## TOWN OF NORTH CASTLE

Subject: Massaro Subdivision – Lot Line Adjustments – Concept Plan Discussion

Original Massaro Subdivision Plat Map

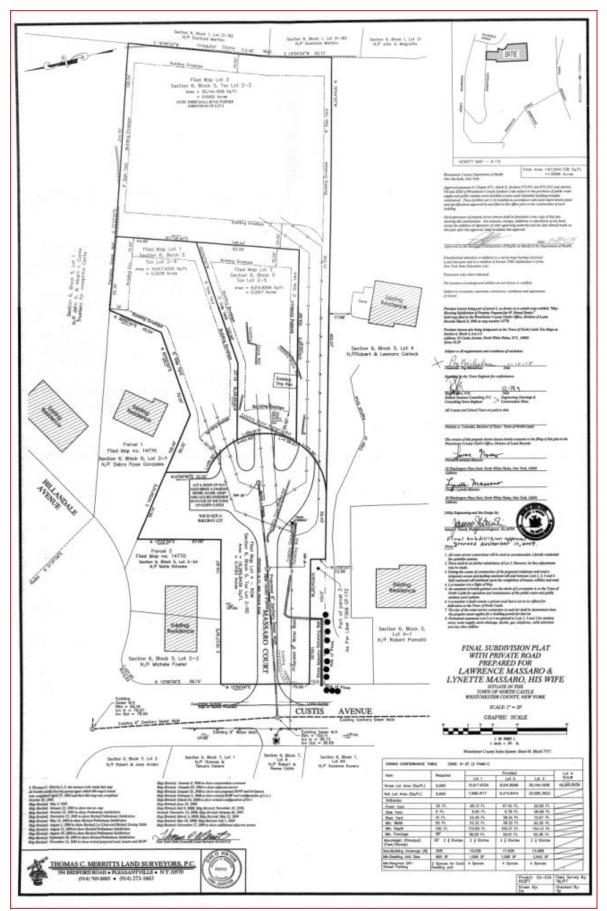
The Applicant has proposed two alternative subdivision lot line adjustments to the original Massaro Subdivision plat map.

The Planning Department does not have a planning objection to either of the proposed alternatives. However, the Applicant must demonstrate that the designs comply with the minimum requirements of the Town Code. Specifically, the following must be addressed:

- Analysis using Net Lot Area. The calculations used to calculate net lot area should be included in the Zoning Analysis Table.
- Analysis of minimum contiguous buildable area via a minimum contiguous buildable area exhibit.
- Analysis/exhibit of average lot width and lot depth for each lot using measurements every 10 feet.
